APPLICATION NO.	FILING DATE	FIRST NAMED INVENTOR	ATTORNEY DOCKET NO.	CONFIRMATION NO.
10/601,083	06/20/2003	George E. Barringer JR.	3551.1005-000	7061

Office Action Summary	Application No. 10/601,083	Applicant(s) BARRINGER, GEORGE E.	
	Examiner Nathan A. Bowers	Art Unit 1744

- 1) ☒ Responsive to communication(s) filed on 06 April 2006.
- 2a) ☒ This action is **FINAL**. 2b) ☐ This action is non-final.
- 3) ☐ Since this application is in condition for allowance except for formal matters, prosecution as to the merits is closed in accordance with the practice under *Ex parte Quayle*, 1935 C.D. 11, 453 O.G. 213.

FIG. 1 PRIOR ART

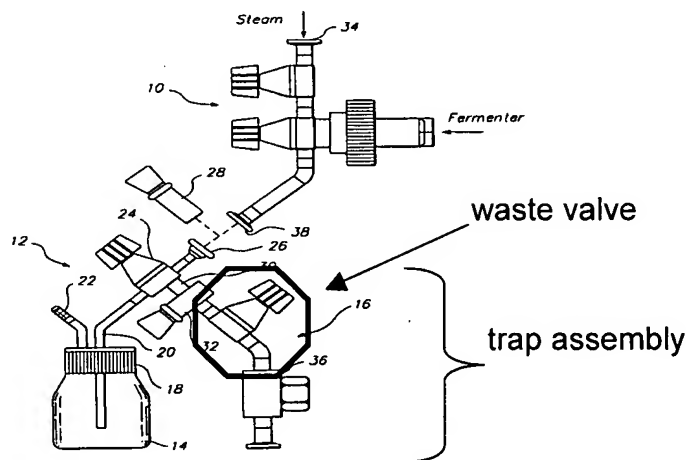
Claims 26 and 46 are patentable. Applicant has clearly defined the trap as "a portion of the sampling conduit extending from the inlet valve to the outlet valve, and the waste valve is coupled to a low region of the trap." The steam trap disclosed by Witte is not a portion of the sampling conduit and the sample does not flow through the trap.

Newberg and Witte are combined to reject the claims based on 35 U.S.C. 103. Newberg discloses a sample conduit through which sample fluid and cleaning fluid are moved. Witte is simply relied upon for teachings that indicate that it is known in the art to supply a trap at the sampling conduit as a means by which to move fluids to a waste site. Witte discloses in Figure 1 a trap assembly and a waste valve coupled to a low region of the trap.

Witte also discloses that it is possible to move sample fluid through the conduit to a waste site. The trap is considered to be part of the sampling conduit because the structures are in fluid communication with each other, and because sample fluids are moved through the trap. When these principles are applied to the existing structure proposed by Newberg, one is left with a trap assembly that is part of a sample conduit and capable of moving sample and wash fluid to the waste site.

Applicant is encouraged to positively recite the structural features that distinguish the trap assembly from the prior art, most notably its "U" shape.
